Nassa Spinners and Garments Ltd. (Extension)

RMG SUSTAINABILITY COUNCIL

2. Observations

Observation-1: Lack of information in Assessment Report

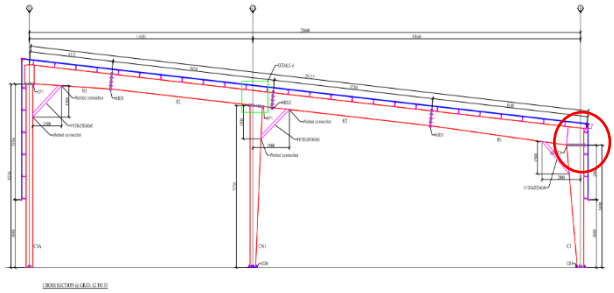
Connection adequacy shown in table of content.

Description: Connection adequacy shown in table of content but not provided in main report. The building engineer is required to update the Assessment Report including all checks as per 1.9.1 of BNBC.
